Banner Associates, Inc. 409 22nd Avenue South Brookings, SD 57006 Tel 605.692.6342 Toll Free 855.323.6342 www.bannerassociates.com

ADDENDUM | No. 1 Viborg-Hurley School Parking Lot Improvements PROJECT BAI: 23301.01.00 **BID TIME &** 1:30 PM Central May 20, 2021 DATE Viborg-Hurley School BID LOCATION 203 West Park Avenue, Viborg, SD **ISSUE DATE** May 17, 2021 Failure to acknowledge all addenda in the BID may cause rejection of the BID. NOTICE See Instructions to Bidders.

SHEET C-906 CONCRETE DETAILS

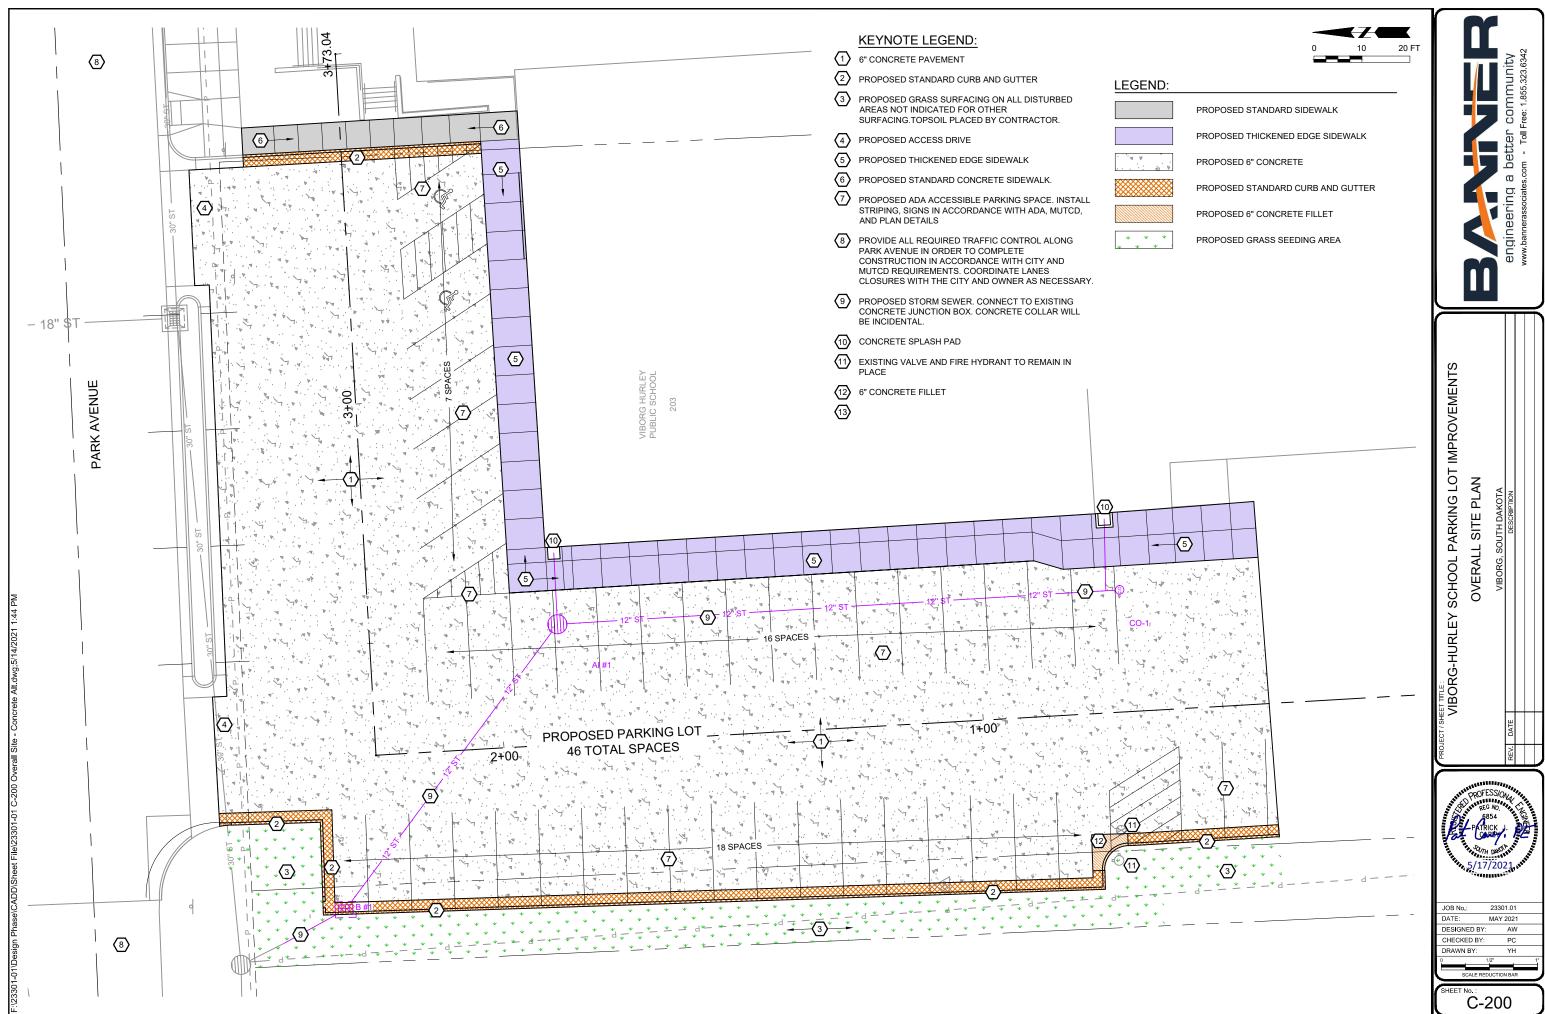
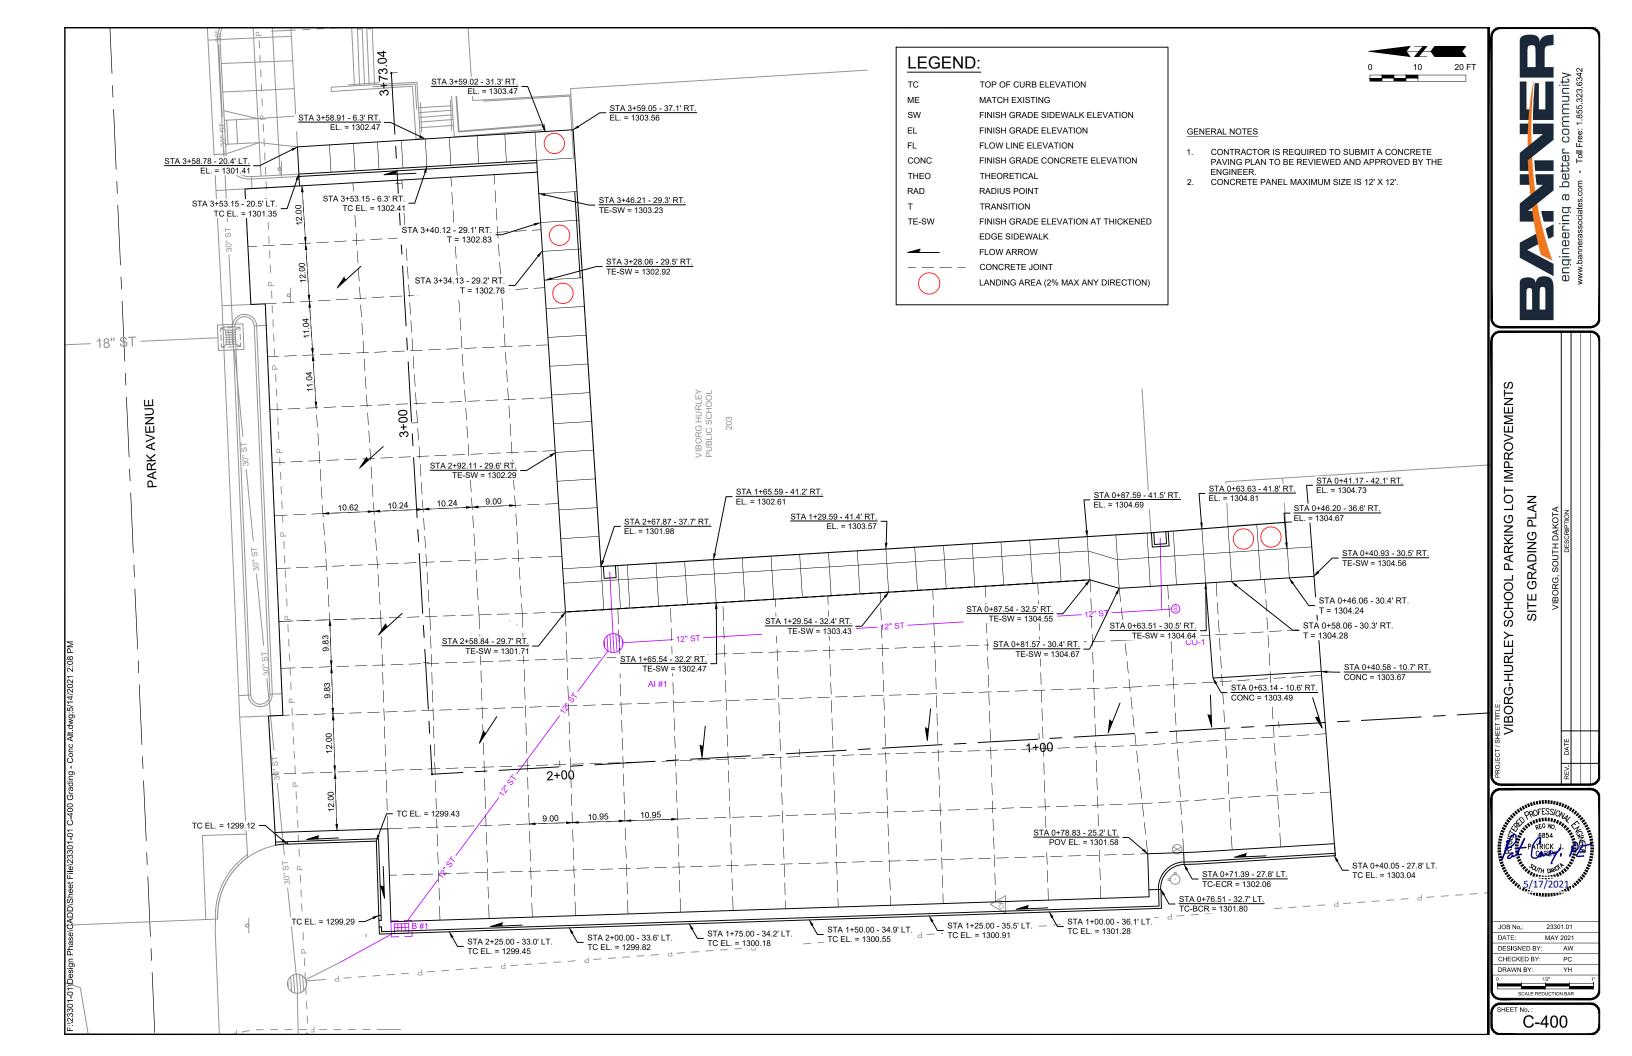
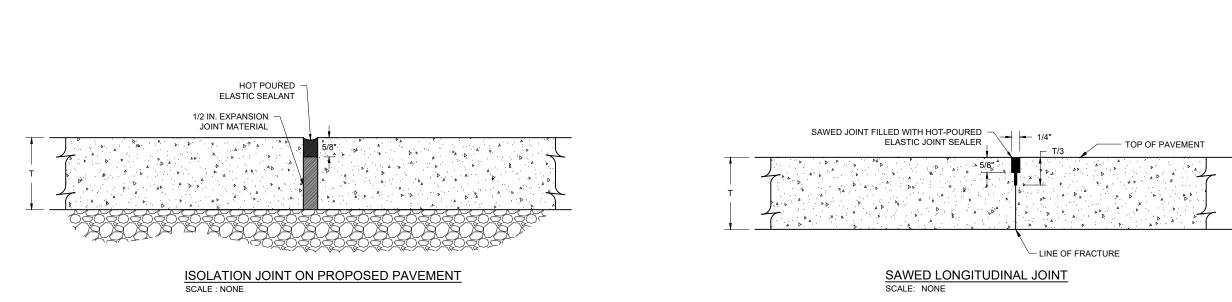
ADD THE FOLOWING SHEETS FOR CONCRETE PAVING

FOR TRANSVERSE CONSTRUCTION JOINTS, THE NO. 4 EPOXY COATED DEFORMED TIE BARS SHALL BE SPACED 12" CENTER TO CENTER AND APPROXIMATELY 6" FROM THE PAVEMENT EDGES.

IF PROPOSED, APPROVAL OF ALTERNATE DESIGNS OF THE KEYWAY WILL BE CONSIDERED BY THE ENGINEER FOR LONGITUDINAL CONSTRUCTION JOINTS. THE NO. 4 EPOXY COATED DEFORMED TIE BARS SHALL BE SPACED APPROXIMATELY 48" CENTER TO CENTER.
